THE SUNRISE CITY
FORT PIERCE
ENGINEERING
DEPARTMENT

**RE : Millcreek PD, FLUMA & Conceptual Site Plan
North of Orange Avenue and W of Hartman Road
Site Plan 22-43900003**

DATE : JULY 11, 2022

TECHNICAL REVIEW PROJECT # 22- 43900003

Attached is a copy of the FPUA GIS Map (Gas).

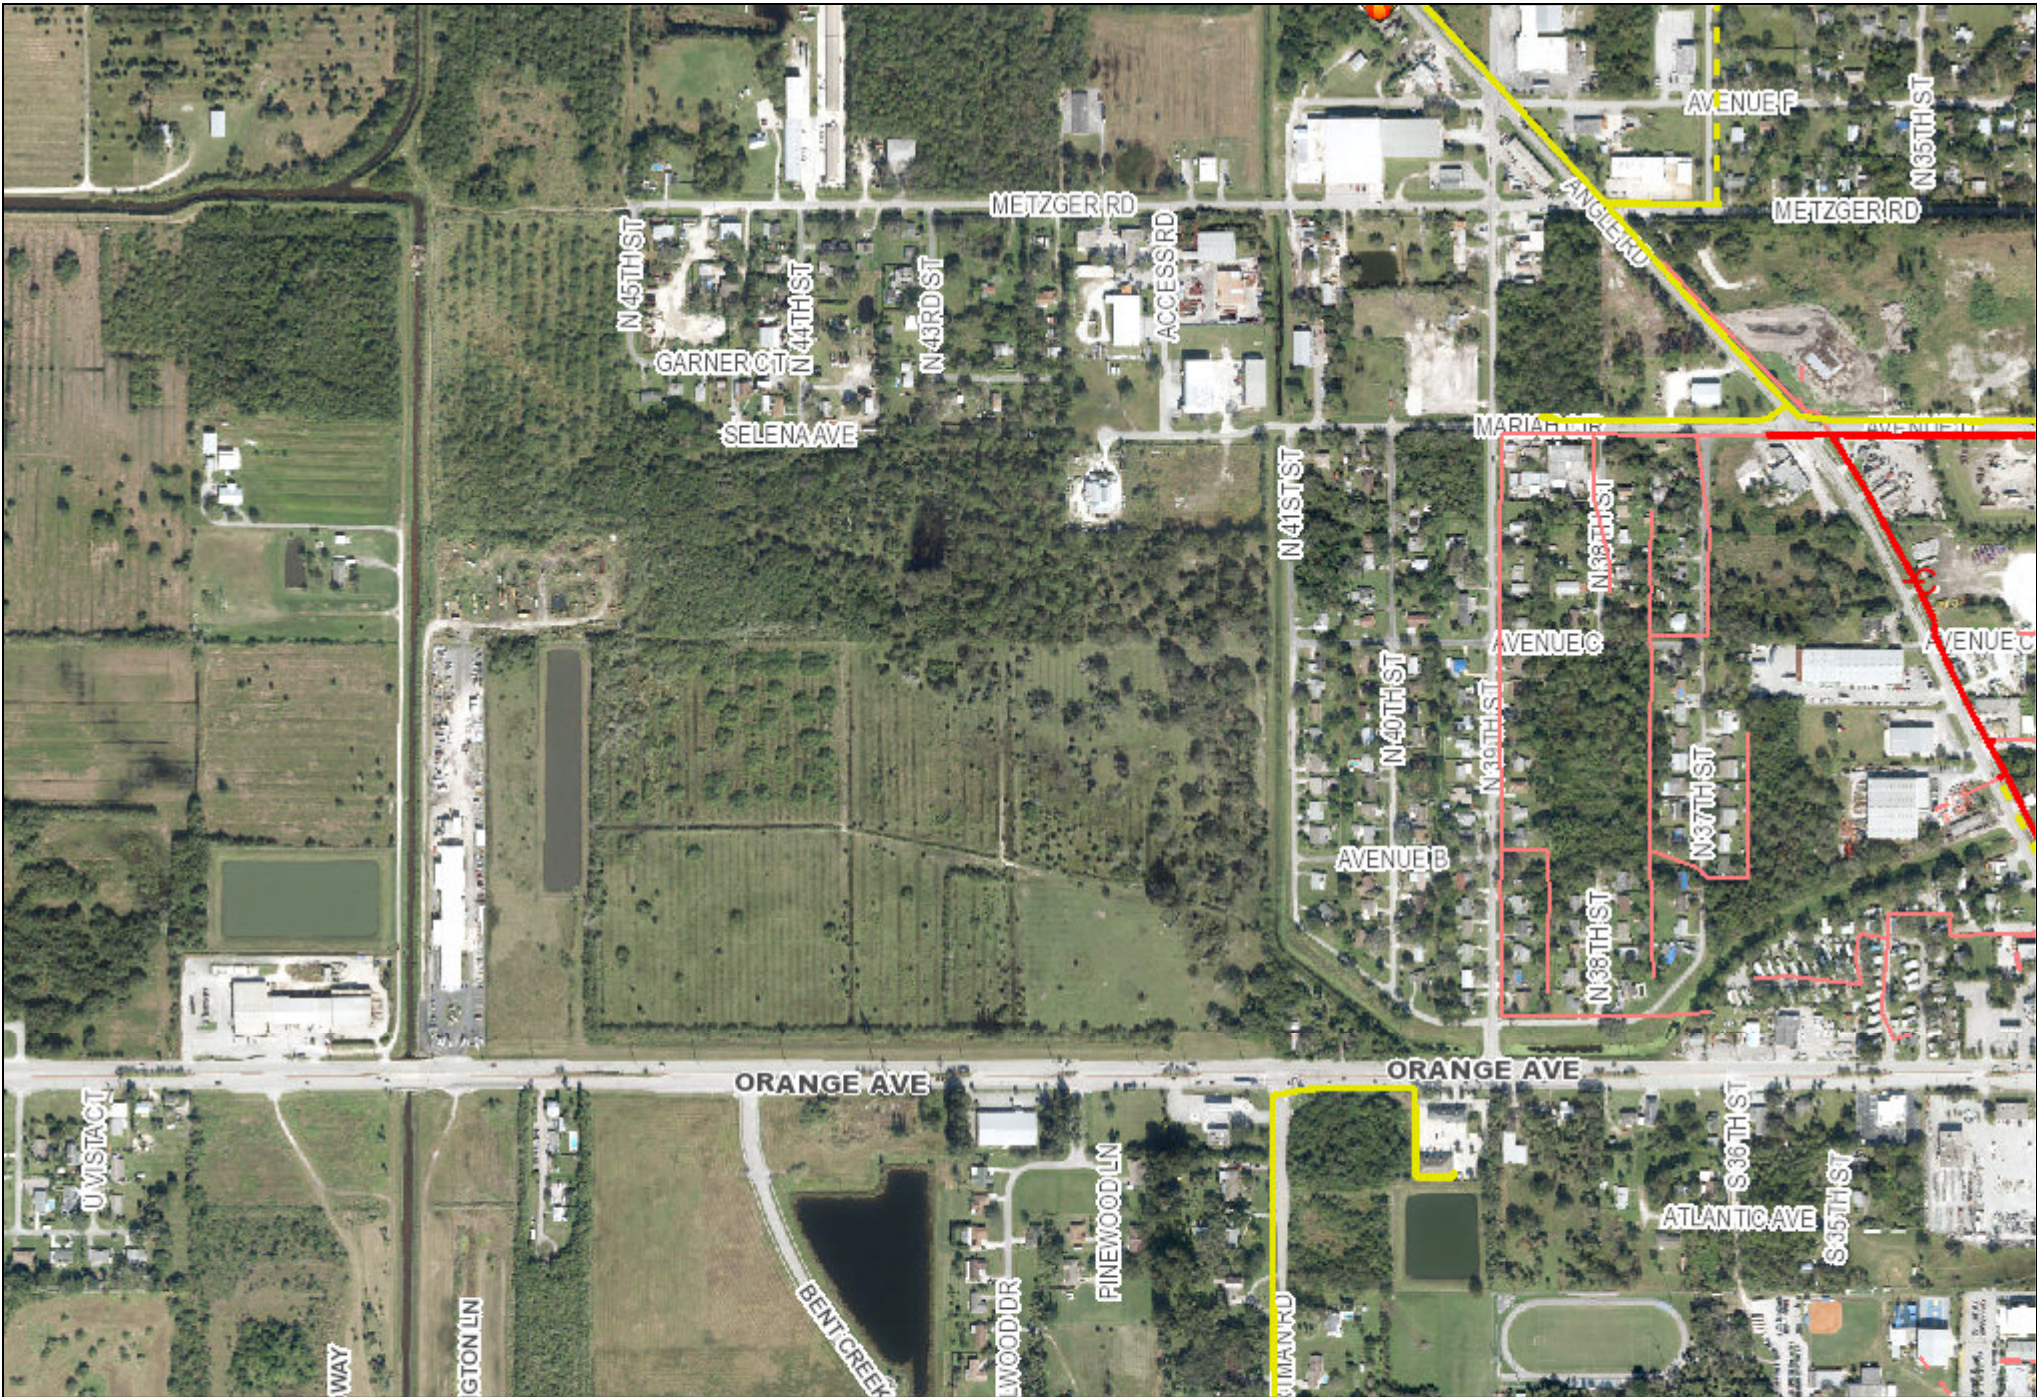
Gas service is available to the site (from the south side of Orange Avenue). Please provide a copy of the gas riser diagram with the anticipated load (if developer is interested in natural gas service). For more information and incentive available, please contact Billy Dupre.

Utility easement may be required for all propose FPUA gas facilities within the site.
